# REQUEST FOR BIDDING INTERPRETATION (RFBI)

PMDB RFBI No.: 25

**Project No.:** 000000000008666  
**Project Name:** DSH-Coalinga Hydronic Loop Replacement  
**Location:** Coalinga, CA

**Drawing Reference:** Sheet M-3.40 **Project Manual Reference:** \_\_\_\_\_

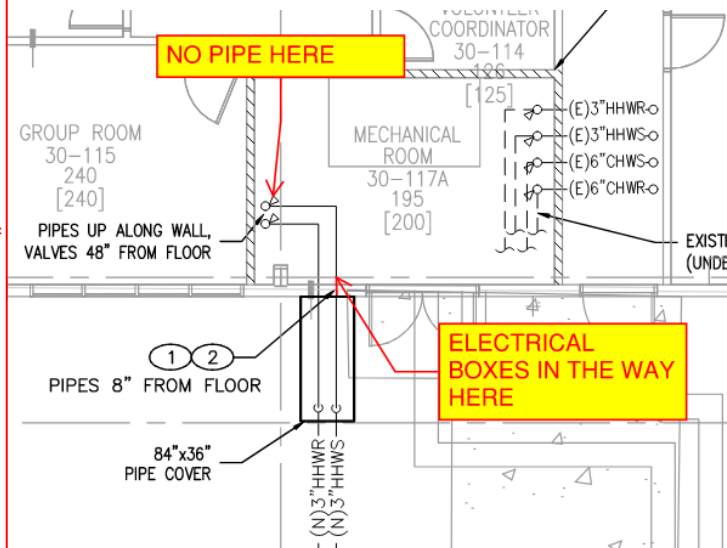
**Question:** Please reference the plan sheet comments shown below.

Based on the project walk, it appears that there are potential conflicts for the hot water connections within Building 30. Namely, the existing piping is not in the location shown and electrical boxes are in conflict at the pipe penetration locations.

Please advise how the Contractor should address this situation in the bid and/or if the Owner will issue a revised drawing.

The two new 3" HHWS and HHWR pipes should instead penetrate the exterior wall to the left of the column (i.e. to the immediate west of column line 15.30). They can penetrate the exterior wall one above the other if lateral space is insufficient. If the two existing pipes are not there on the west interior wall where indicated in the RFBI plan excerpt, then only connect the new pipes to the existing 3" HHWS and HHWR pipes along the east interior wall where shown on the "Phase 3: Provide New HHW Pipes" plan on Drawing M-4.30.
